- Subject : Free play in automatic elevator hook-up, adjustment
- Effectivity type: DG-single seaters  
variants: All types and variants with automatic elevator hook-up only. This TN is not valid for variants with l'Hotellier connections in the elevator control.
- Accomplishment : Latest 3 months after the effective date of the relevant AD or with the next annual airworthiness review, whichever comes first.
- Reason : On a DG-300, the rod end at the upper end of the elevator pushrod in the fin broke off at the thread.  
It was found that the elevator play adjustment screw was turned in too far, which caused jamming of the roller inside the funnel. The roller couldn't be moved up to the front of the funnel, even with higher force.

Figure 1, schematical view of elevator

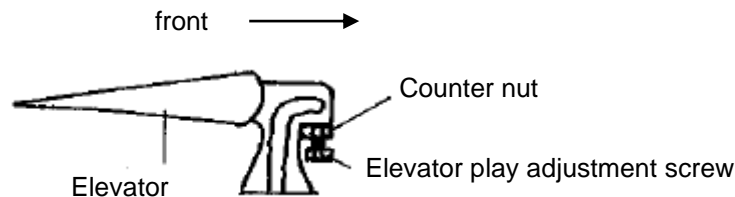
Thereby each time when rigging and during operation a bending force acted on the rod end, which caused failure of the rod end with time.  
As the type of automatic elevator hook-up is similar in all DGs equipped with automatic hook-up, the following instructions are valid for all affected DG gliders and motor gliders.

Since the instructions for adjustment of the free play in the maintenance manuals are insufficient, these will be amended.

In addition, a check of the automatic elevator hook-up is required.

Figure 2, look through the inspection window DG-600

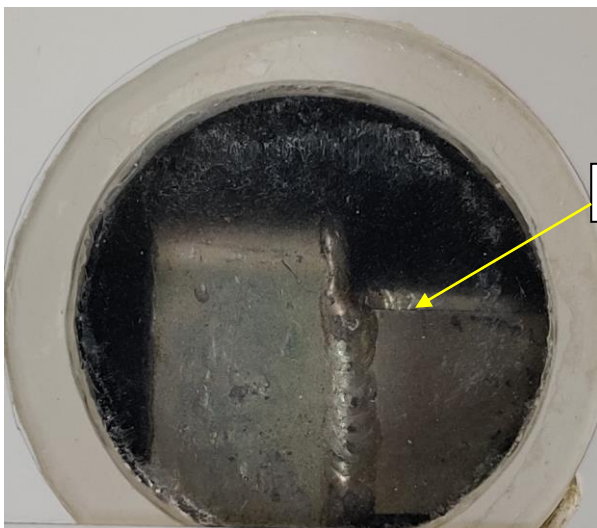
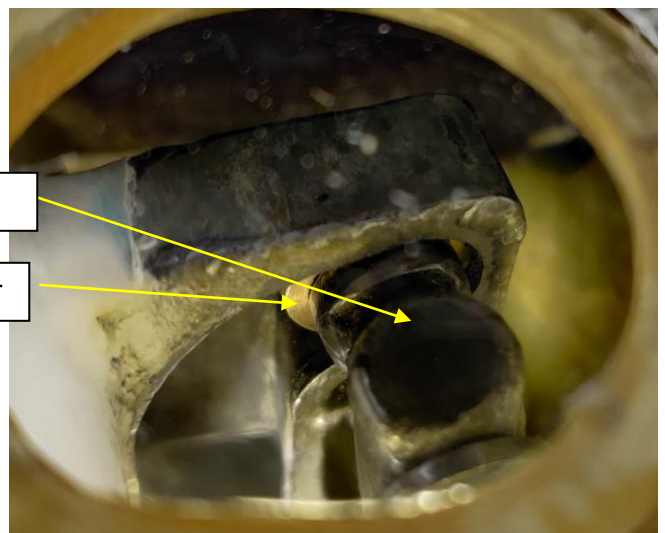
- 2.5 Rig the horizontal tailplane and when moving it backwards, monitor that no larger force is needed. By looking through the Plexiglas window at the upper surface of the stabilizer, check if the roller will be moved up to the front end of the funnel, see also the photos at the end of this TN.

Check the elevator deflections and adjust if necessary.
